NOTICE PLAN COMMISSION September 15, 2015

NOTICE PLAN COMMISSION September 15, 2015

TO: Plan Commission
FROM: Tom Hovel, Zoning Administrator/City Planner
Susan Badtke, Community Planner
DATE: September 10, 2015
SUBJECT: September 15, 2015 Plan Commission Items

PERVIOUS AREA: 29650 sq.ft. (71.7%)

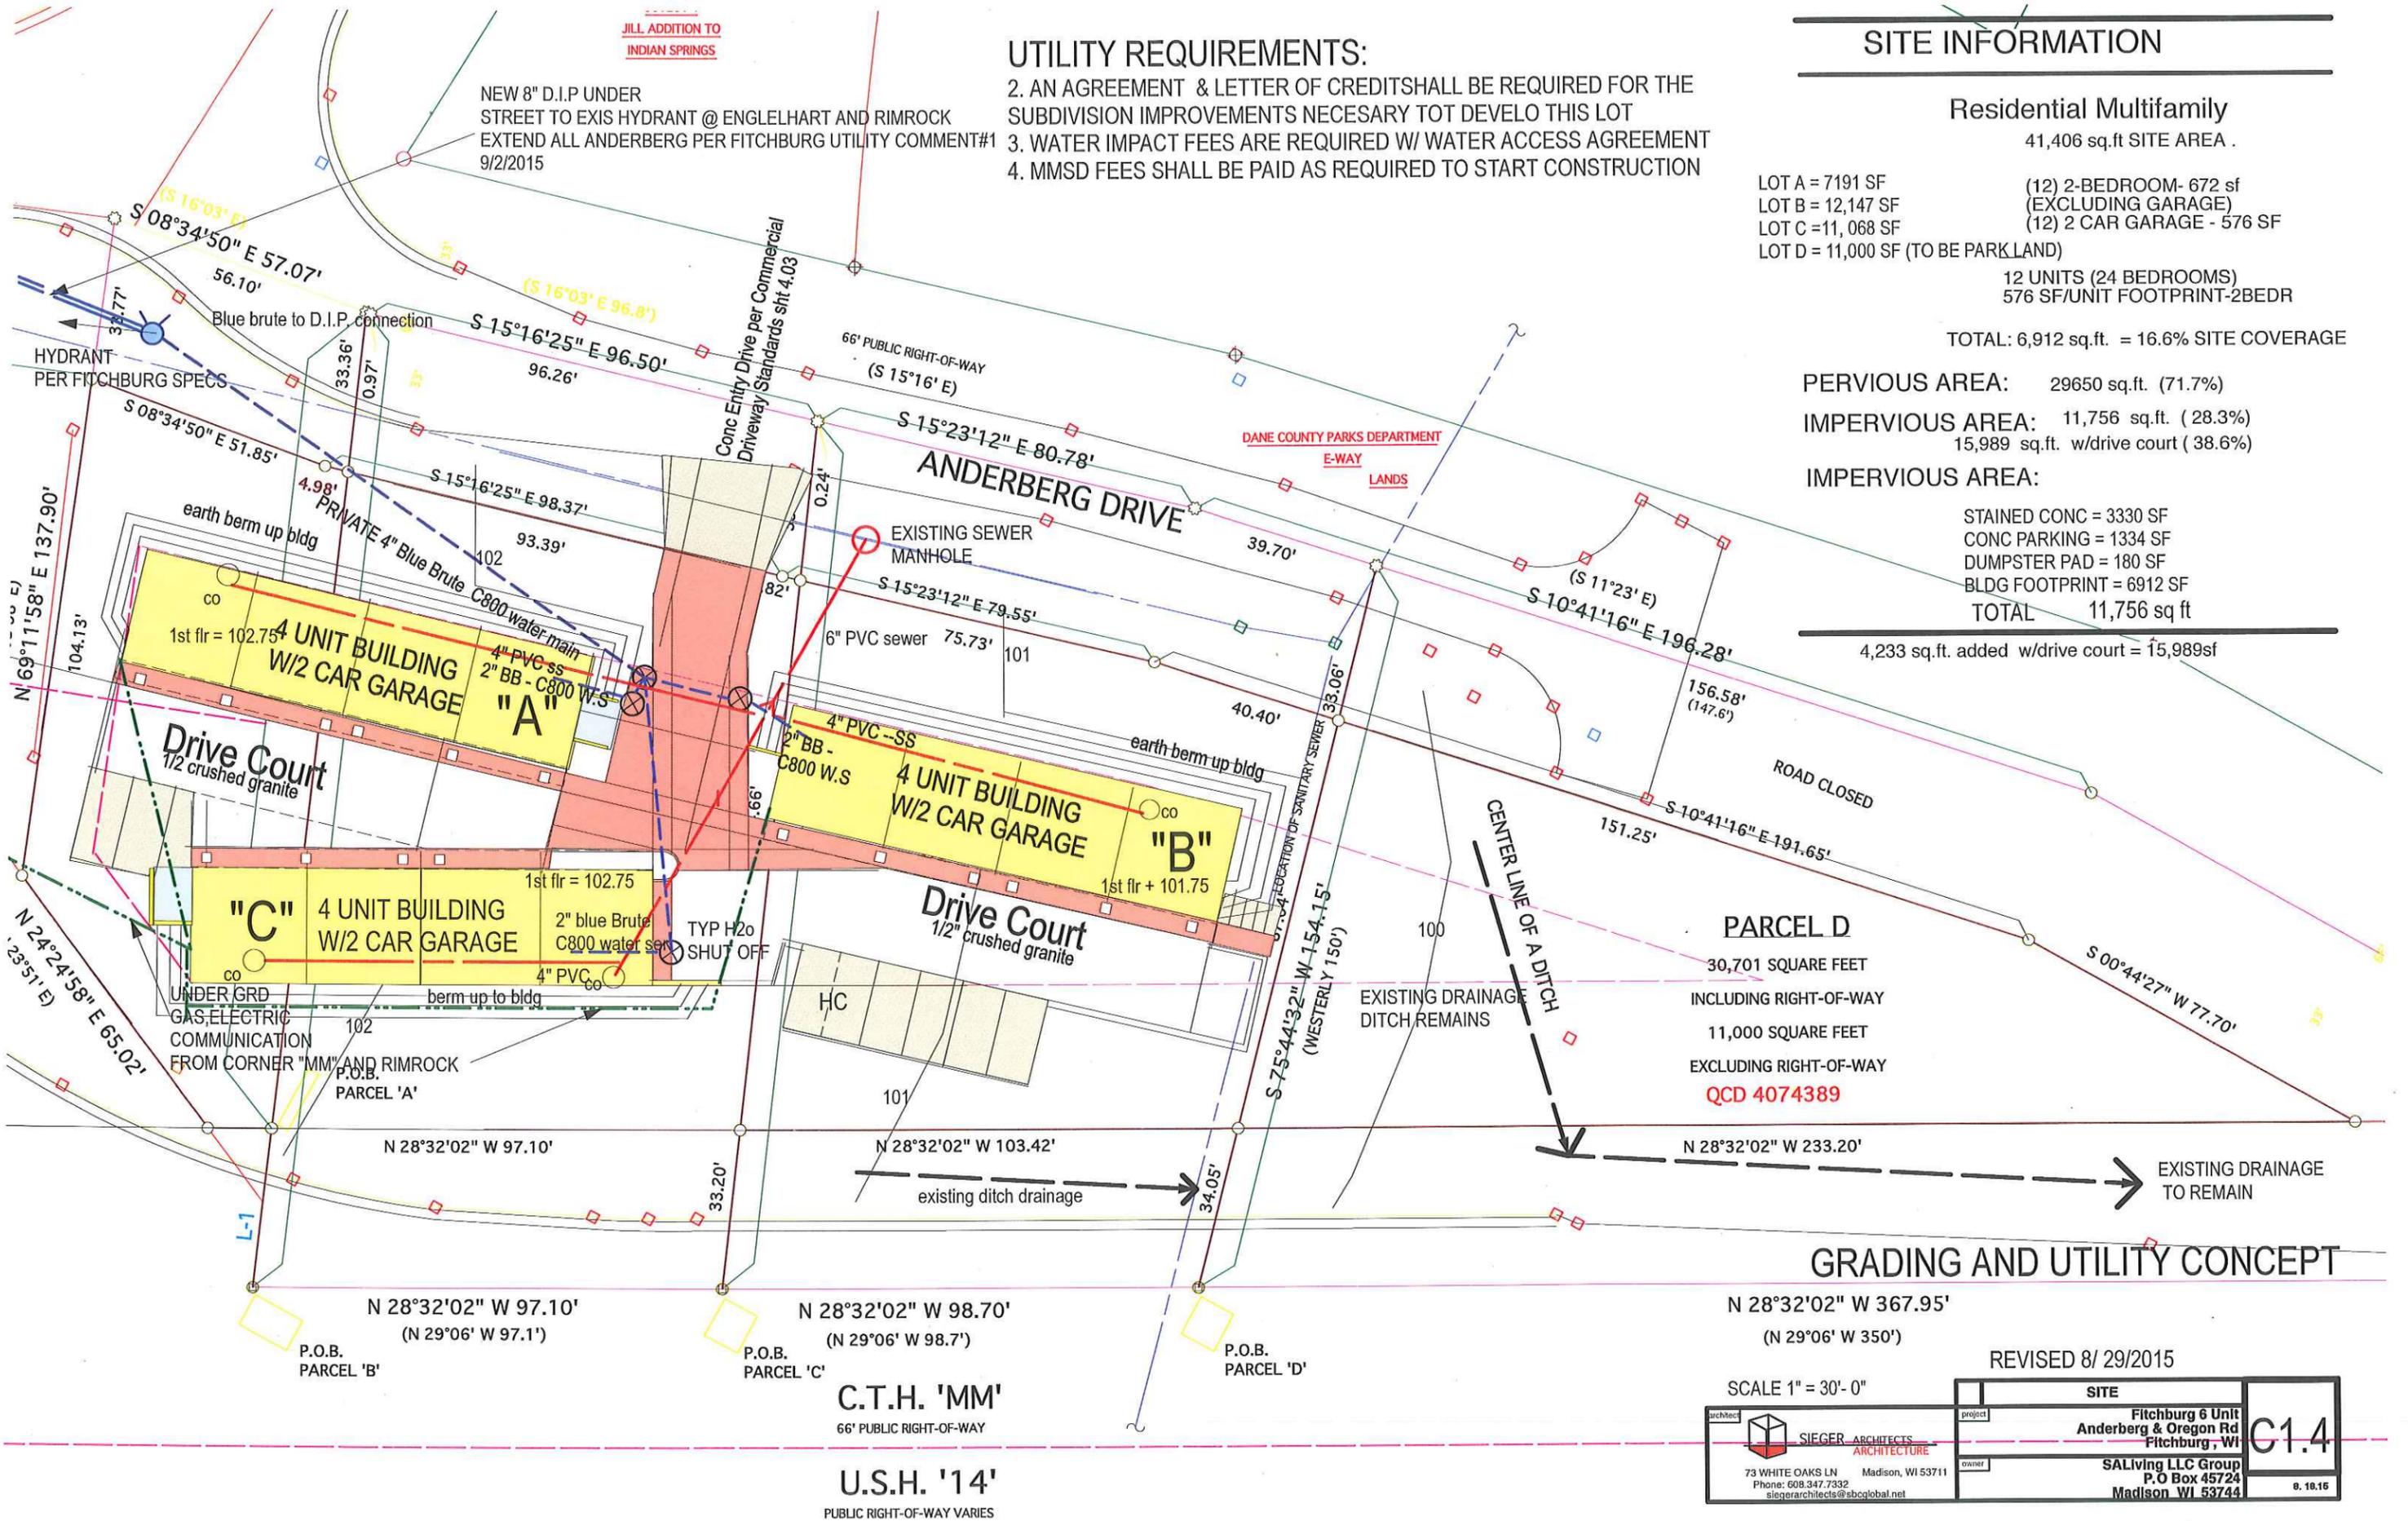
3. Sheet C1.1 shows two proposed parking stalls extending onto parcel D, which is the land to be dedicated for parkland. These stalls will need to be a minimum of two feet from the property line. There are two options:

- a. Adjust the parcel line for parcel D
 - b. Shift the parking stalls to the north
4. Please update the elevation drawing, sheet A4.1, to detail the building height as there is no scale on the drawing.

1 SITE PLAN
A100 SCALE: 1" = 30'-0"

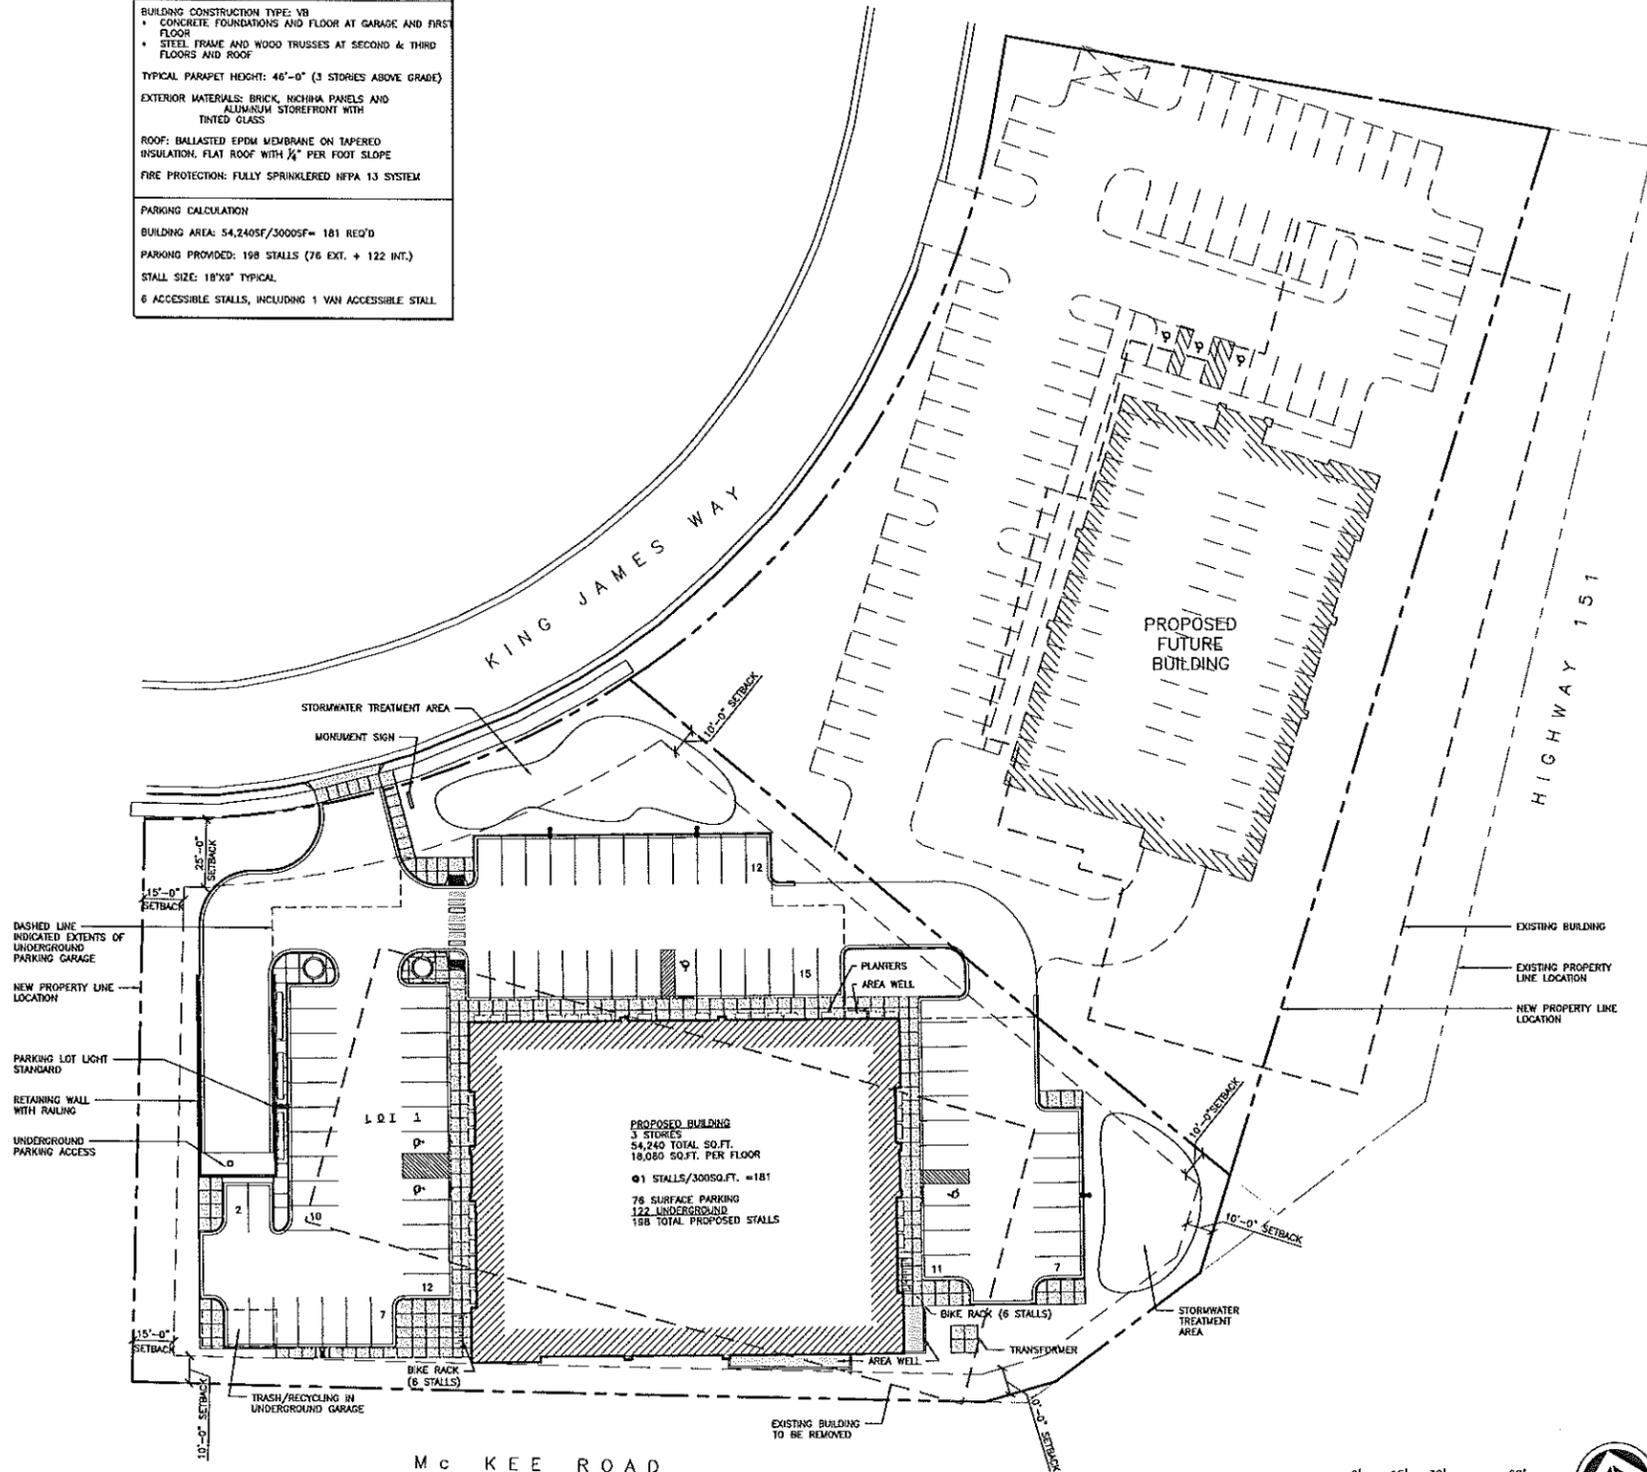
- a. Sheet A100 notes the wrong parking standard of 3 stalls per 1,000. Please update to reflect correct standard. **It is understood that the parking proposed exceeds the required ratios, but the desire is to provide adequate parking for the intended uses based on historic data and anticipated user numbers. Sheet A100 will be revised to reflect the correct parking standard of 1 stall per 300 sf.**
